Planning Commission Hearing Date: September 9, 2025
Board of Commissioners Hearing Date: September 30, 2025

STAFF ANALYSIS

Case No.:	Z-25-1247529	Agenda #: 2025-0628
Address:	3265 Northeast Expressway, Chamblee, GA 30341	Commission District: 01 Super District: 07
Parcel ID(s):	18-267-01-003	
Request:	Rezone property from C-2 (General Commercial) zoning district to HR-1 (High Density Residential-1) zoning district to allow single-family, attached, and multi-family developments.	
Property Owner(s):	Reality Income Corporation	
Applicant/Agent:	LMPSF acquisitions, LLC. c/o Troutman Pepper Locke, LLP	
Acreage:	36.46 acres	
Existing Land Use:	Formally Regal Cinemas	
Surrounding Properties:	North: OI (Office Institutional) East: OI South: MR-2 (Medium Density Residential -1), R-100 (Residential Medium Lot-100) West: C-2 (General Commercial).	
Comprehensive Plan:	RC (Regional Center) Consistent X Inconsistent

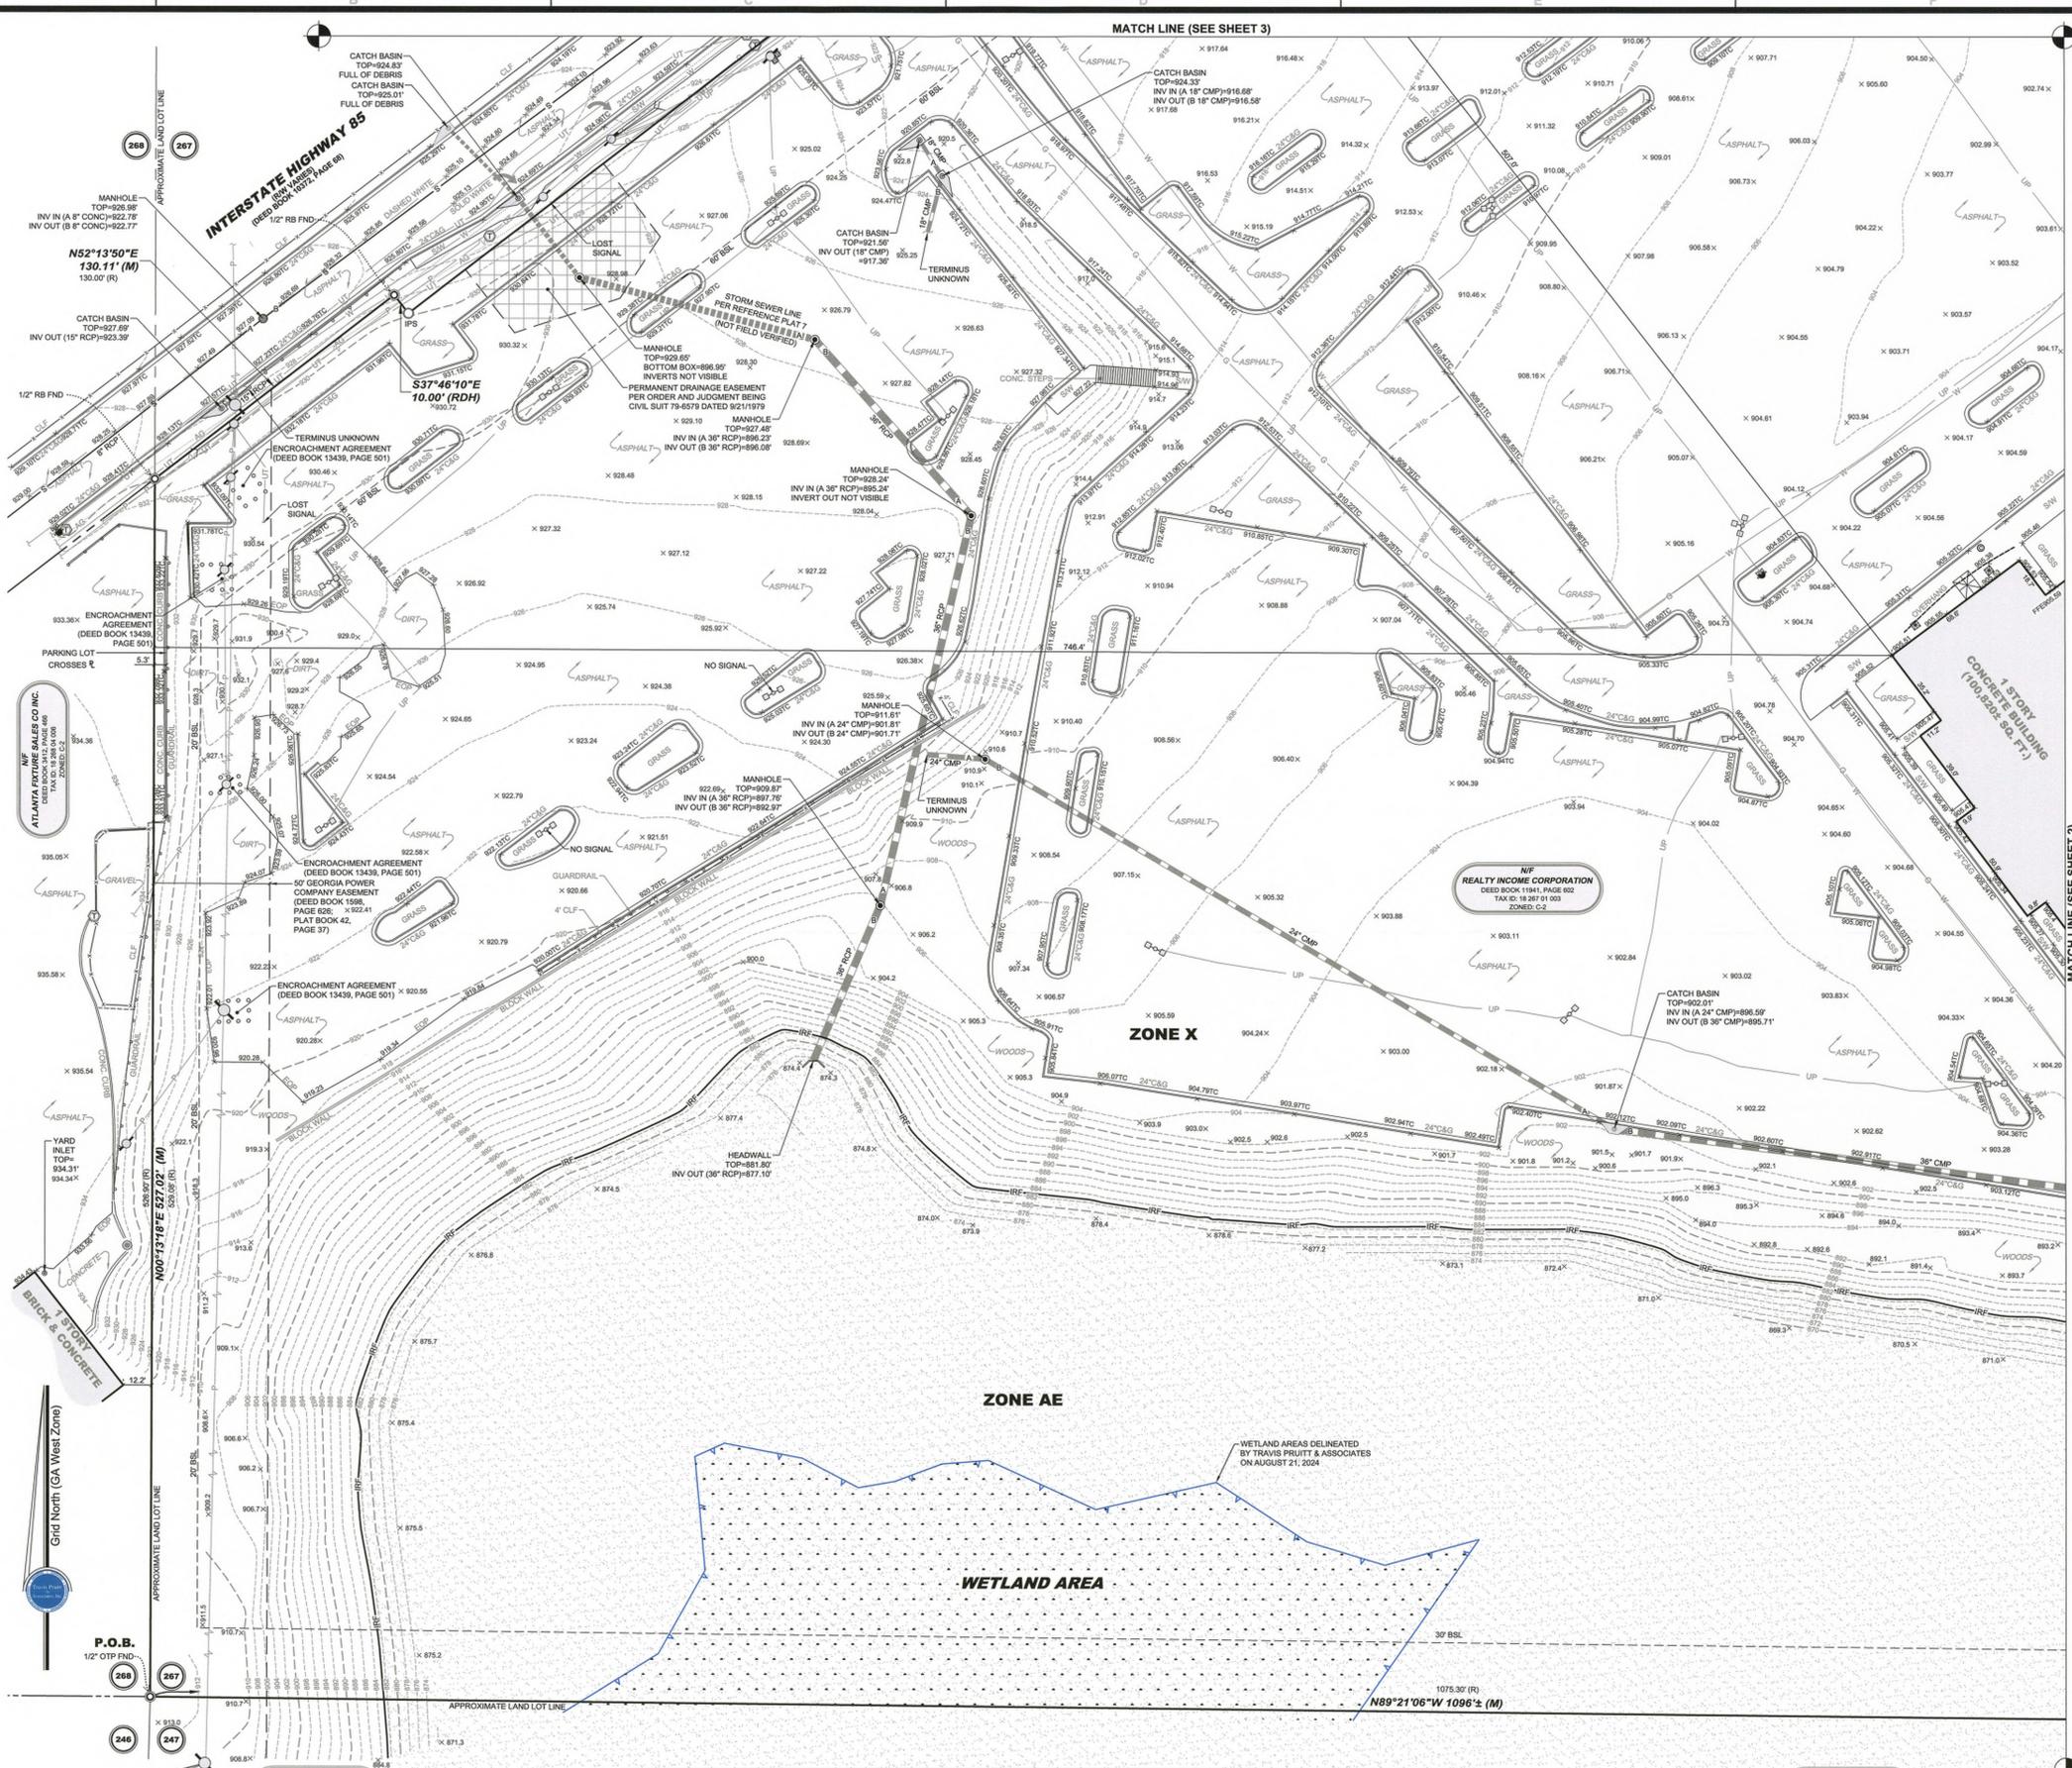
building heights up to 10 stories. Verify with Atlanta Regional Commission that Development of

parking. While this property is not within a Small Area Plan, the abutting property to the south is

within a Small Area Plan--please review to see what impacts it might have on proposed project

provision of density bonuses. 30 foot transitional buffer required where abutting MR-2 zoning to sc

application is submitted. Where is detention being provided.
